STATE OF NORTH CAROLINA
DEPARTMENT OF TRANSPORTATION

October 18, 2022

Subject: Request for Modification to Section 404 Individual Permit and Section 401 Water Quality Certification for the I-26 Widening from NC 225 (US 25 Connector) in Henderson County to I-40 in Buncombe County, Federal Aid Nos. NHF-26-1(62)23 / I(MNHF-026-1(86)9, TIP Project Nos. I-4400/ I-4700; Divisions 14 / 13. Debit \$570 from WBS No. 34232.1.6

PERMIT DRAWING
SHEET 59 OF 97

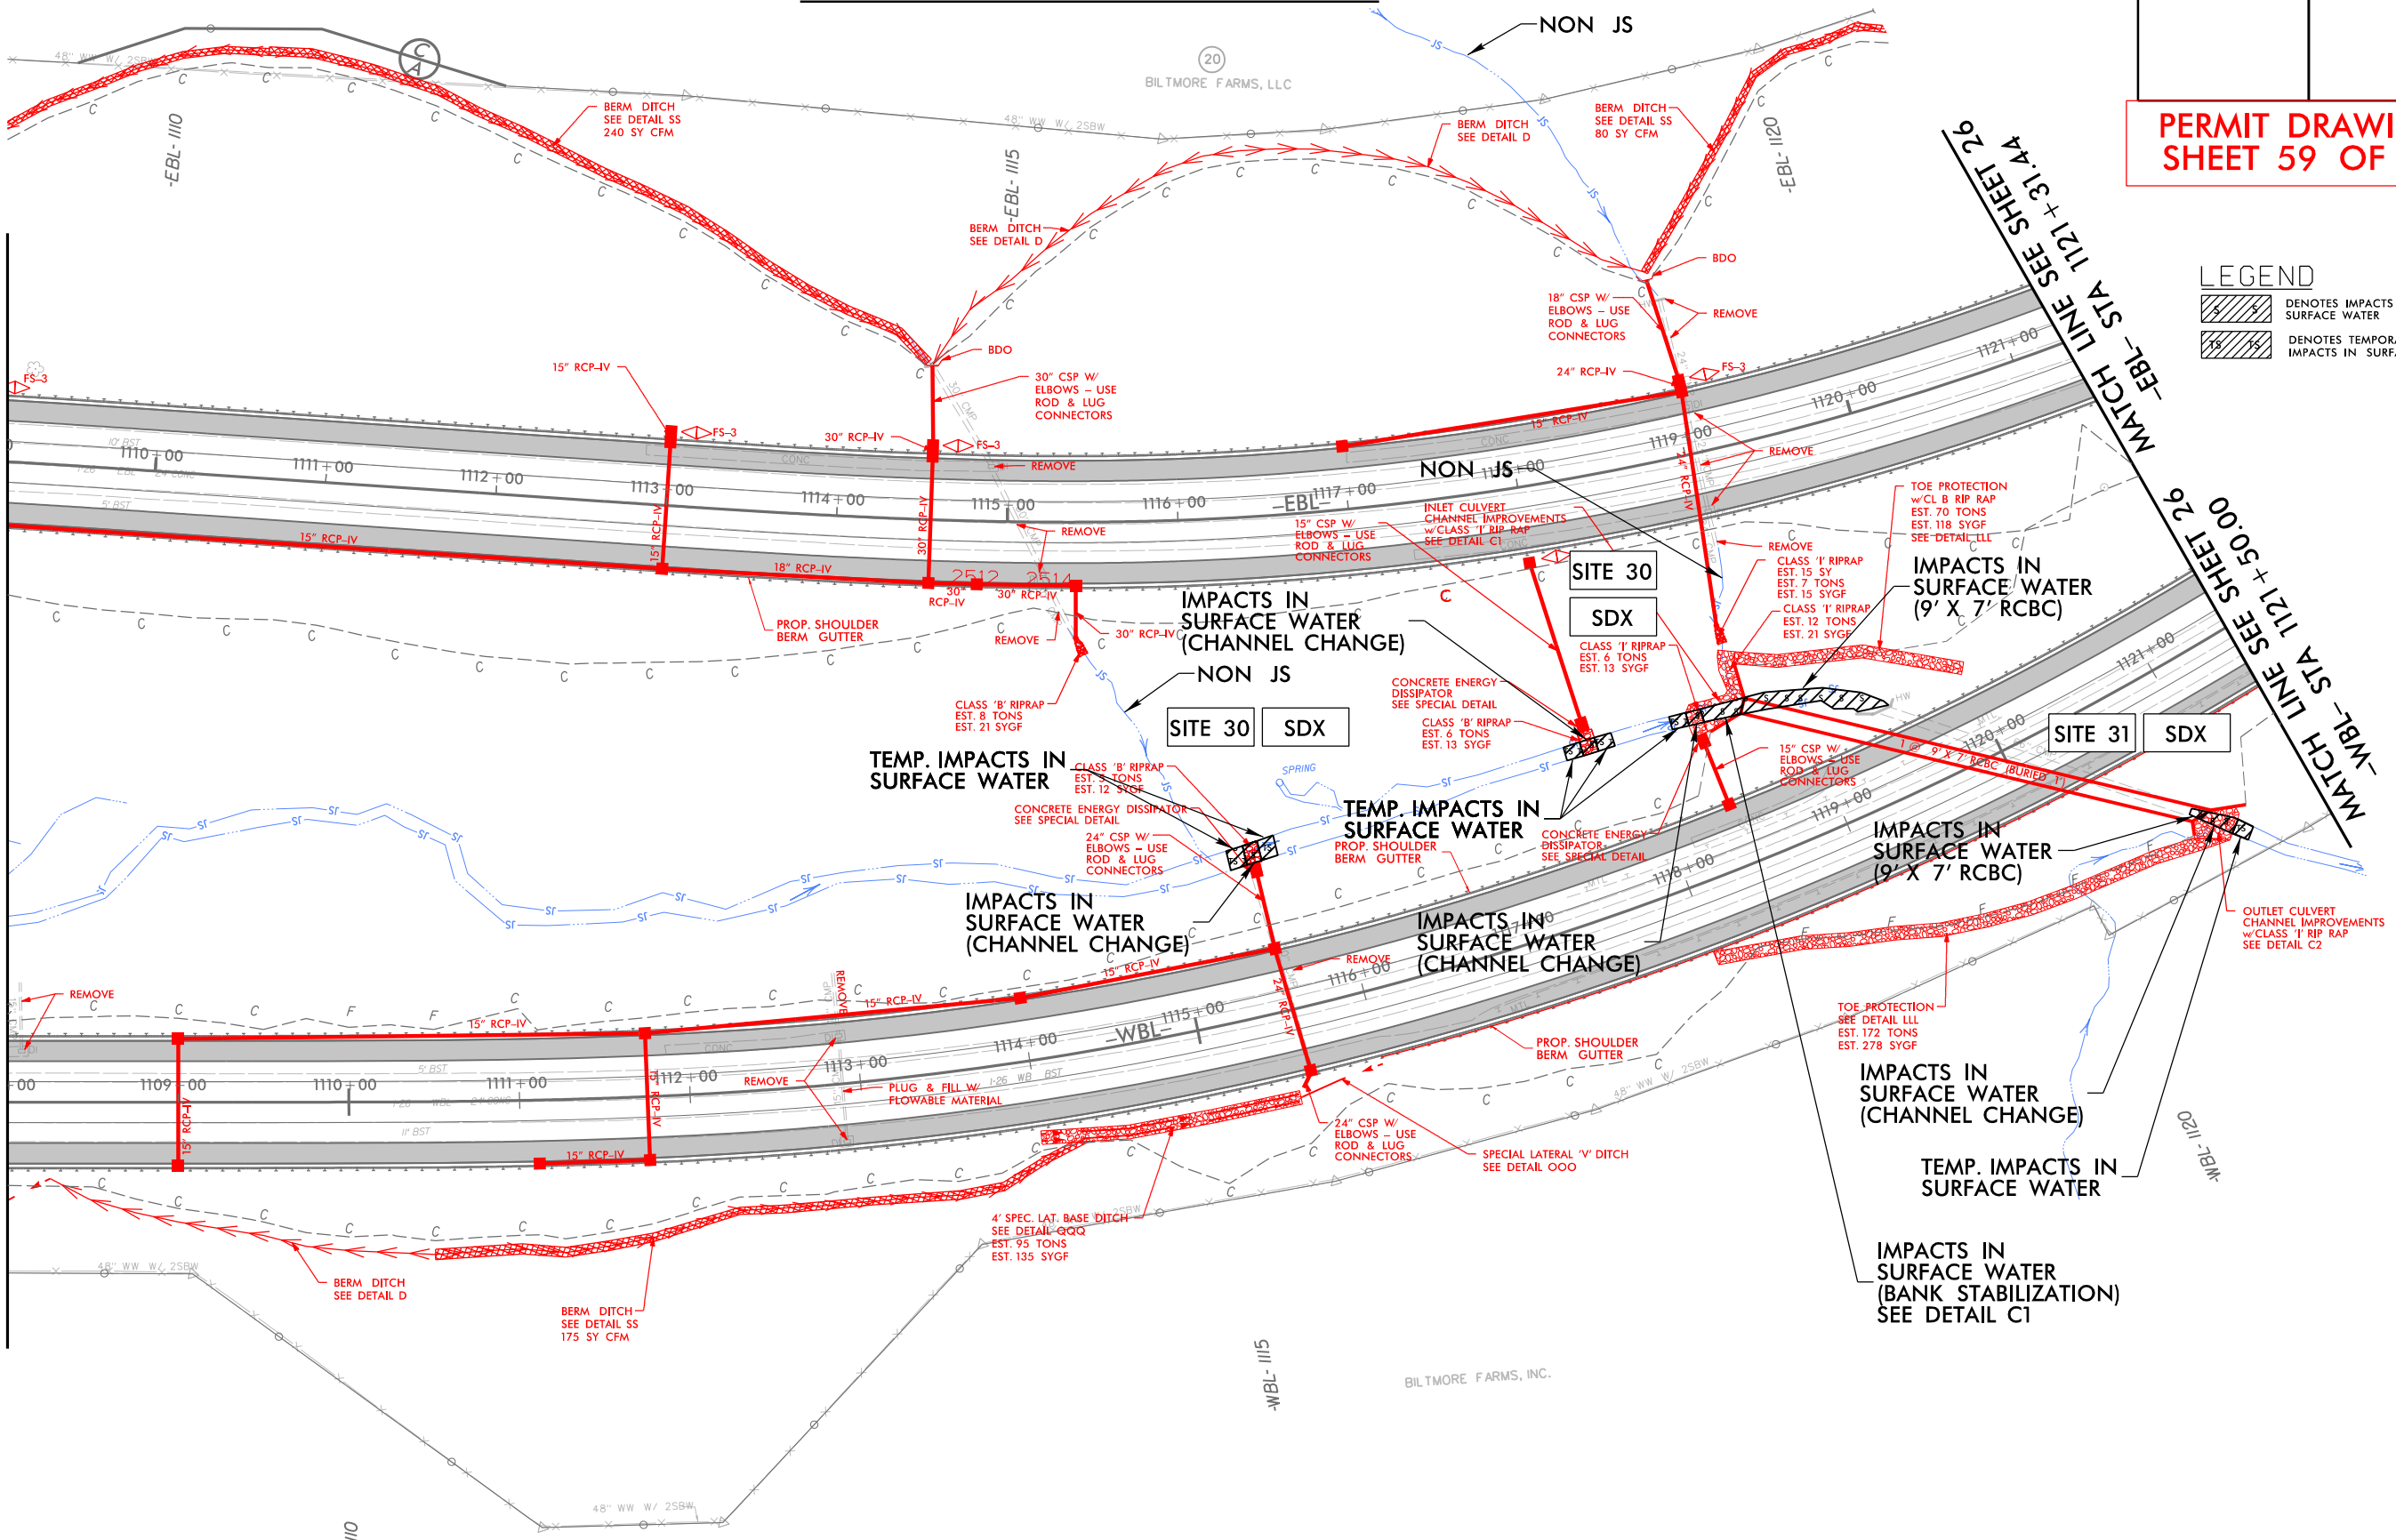
Site 30 (Permit Drawing Sheet 59) – This site has been updated to replace the existing 66” RCP with a 9’x7’ RCBC. This will include riprap bank stabilization along stream SDX. Changing the pipe to a box culvert will reduce temporary impacts upstream at the outlet of the proposed 15” Corrugated Steel Pipe (CSP). The replacement of the 66” RCP with the 9’x7’ RCBC will result in an increase in permanent impacts to the stream from 70’ to 78’. A net total increase of 8’. Riprap is proposed at the inlet of the RCBC for bank stabilization. The additional bank stabilization is a new permanent impact of 25 feet.

Site 31 (Permit Drawing Sheet 59) – This site has been updated to reflect the proposed replacement of the existing 66” RCP with the 9’x7’ RCBC. The new RCBC will result in 8 feet of permanent stream impacts compared with the original 38 feet, and zero (0) temporary impacts, reduced from 10 feet. This results in a decrease of 30 feet in permanent impacts and 10 feet in temporary impacts. However, the new channel change (with embedded riprap) as a result of the proposed RCBC will result in 20 feet of new permanent impacts and 10 feet of new temporary impacts.
